RE: Docket No. 24-34-EL - Development of Tariffs Applicable to Energy Storage Systems Connected to the Electric Distribution Systems

Stakeholder Comments (second set of interconnection responses – *in italics*) in Response to Docket 24-34-EL Storage Workshop #10 Presentation (second set of interconnection responses) on August 6, 2025

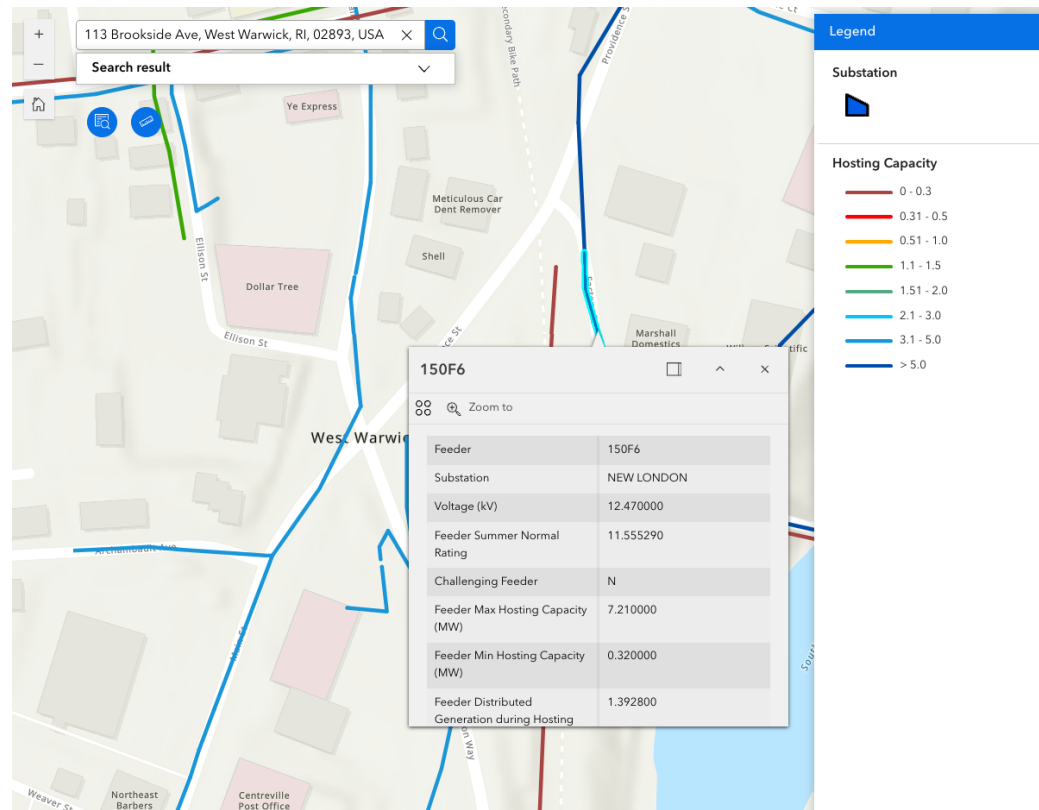
- Stakeholder Prompts
 - P.13: Study Process
 - Is there additional data or information you would like to see in the Pre-Application Report (e.g., 8760 data) to inform ESS siting and design?
 - The Hosting Capacity Analysis map is meant to be a helpful tool but it remains unclear how hosting capacity values are visually represented on the map and what the true value of available hosting capacity is on a feeder.*
 - Example: New London feeder 150F6 – see screenshots below:*

Color from the legend indicates 3.1-5.0 MW of available hosting capacity but there is no data in the table that matches with this designation

Color from the legend indicates >5.0 MW of available hosting capacity but there is no data in the table that matches with this designation
